## Water Resources Consultant

Re: The Sanctuary, School Street, Manchester, MA

At your request, I have reviewed the required waivers from the local Manchester-by-the-Sea wetlands Bylaw and Regulations. I have also reviewed the responses by the Applicant to my prior comment letters.

Exhibit A - Site Plan with Encroachment

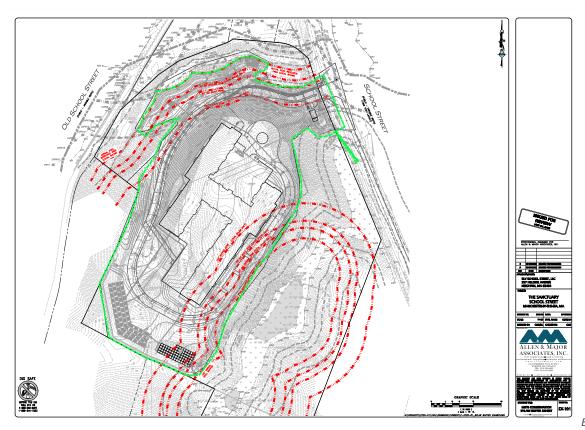
- **1. Encroachment in "No Build" and "No Disturbance" Zones:** The proposed project encroaches on the "no build" and "no disturbance" zones associated with the vernal pools as defined under the Manchester Wetlands Bylaw and Regulations (Section 10.1 of the Manchester Wetlands Bylaw). See Applicant's Bylaw Buffer Exhibit dated 5/24/22, attached hereto as Exhibit A. The portions of the Project within the depicted local Bylaw buffer zones would require waivers.

To my knowledge, no alternatives analysis has been provided. It is clear that if the project were reduced in size, the loop road circling the building could be kept outside of these "no build" and "no disturbance" zones. However, this type of alternative plan was not provided or evaluated. As there has been no alternatives analysis, there is no legitimate basis for a waiver.
